P14-1186
Exhibit A, Conditions of Approval

8019 Golden Eagle Way
March 25, 2015

Thank you for submitting your application for a Design Review approval for the construction of an approximately 6,841-square-foot, two-story custom home on an approximately 47,200-square-foot lot located in the Golden Eagle Farms at 8019 Golden Eagle Way within the PUD-LDR (Planned Unit Development – Low Density Residential) District, dated received on September 17, 2014.

PROJECT NAME
GRADED AREA
LOT 2 TRACT 5945
CITY OF PLEASANTON
ALAMEDA COUNTY, CALIFORNIA

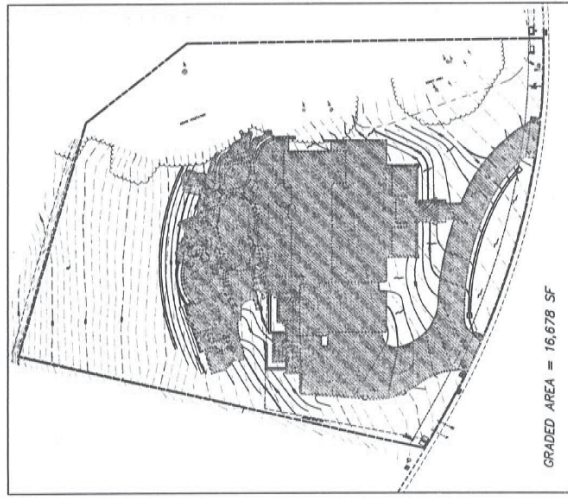
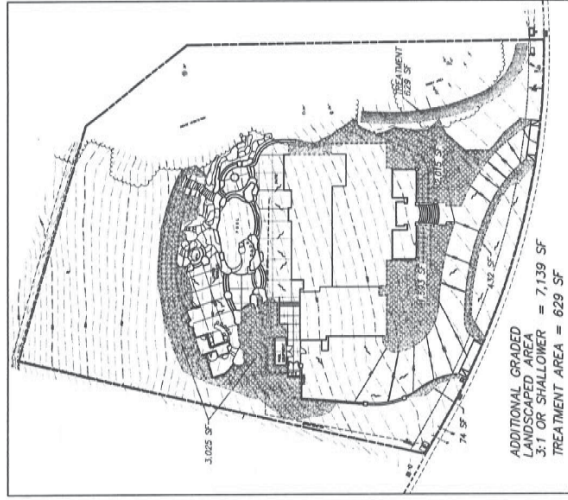
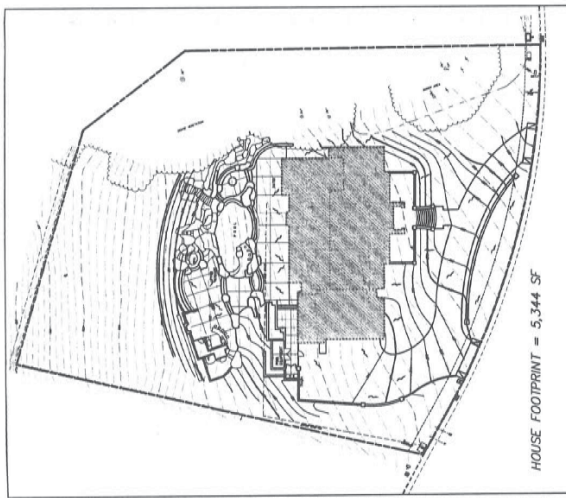
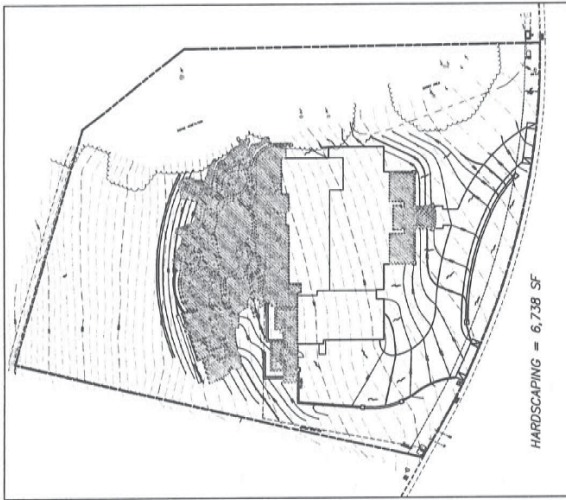
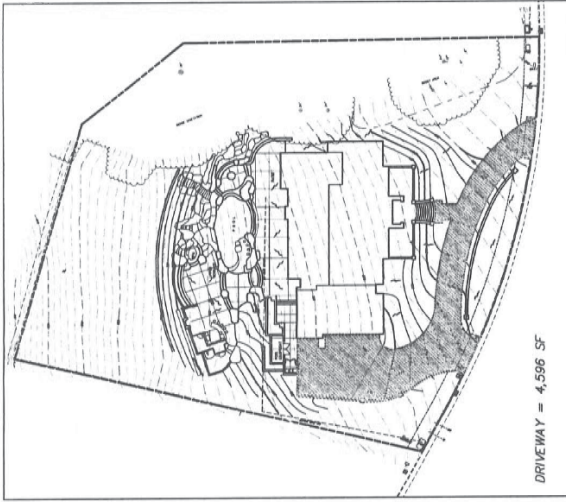
As a final note on grading, on February 5, 2015, Gary Monzo reviewed materials submitted to the Planning Department concerning the 8019 Application, including the grading plan from Alexander & Associates, Inc. (“Grading Plan”) (Attached hereto as Attachment K) which purportedly provides a complete grading plan and calculates the grading square footage for all areas on the property. That map identifies total grading for the house (5,344 s.f.), hardscape (6,738 s.f.), driveway (4,596 s.f.) and landscaping at a slope of 3:1 or shallower (7,139 s.f.). Consistent with the Guidelines, the total grading for the 8019 Application would thus be 23,817 – well in excess of the maximum amount allowed under the Guidelines and your October 14, 2014 letter. That same day, however, my client raised this issue with you, to which you advised him that the Planning Department changed its interpretation of the grading guidelines to provide that the term “exterior gardens” did not include landscaping, thus making the grading compliant with the Guidelines.⁶

Moreover, notwithstanding the interpretation issues outlined above, there appears to be a gross misrepresentation of the grading area as shown on the Grading Plan, when compared to the actual Planting Plan (undated) submitted by Martin Hoffmann (“Planting Plan”). We presume that the Planting Plan is part of the Planning Department’s records for the 8019 Application, and specifically note that when examining page L-3 of the Planting Plan, it appears that the 8019 Application anticipates landscaping on both the northeast and southeast corners of the property, as well as the easternmost border between the street and driveway. However, notwithstanding these very clear markings on the Planting Plan, none of these areas appear “shaded” in the Grading Plan, let alone in the landscaping portion thereof.

Again, while this may be an oversight or miscalculation as between outdated plans and calculations, the frequency of which these issues are arising is disconcerting. Indeed, just eyeballing these "unshaded" areas in Grading Plan which appear to be landscaped per the Planting Plan, there may be another several hundred square feet wholly unaccounted for in the Grading Plan. In short, until we have a clear set of plans identifying all grading, and which are consistent with all other plans on in the 8019 Application, any decision thereon would simply be made on incomplete information.
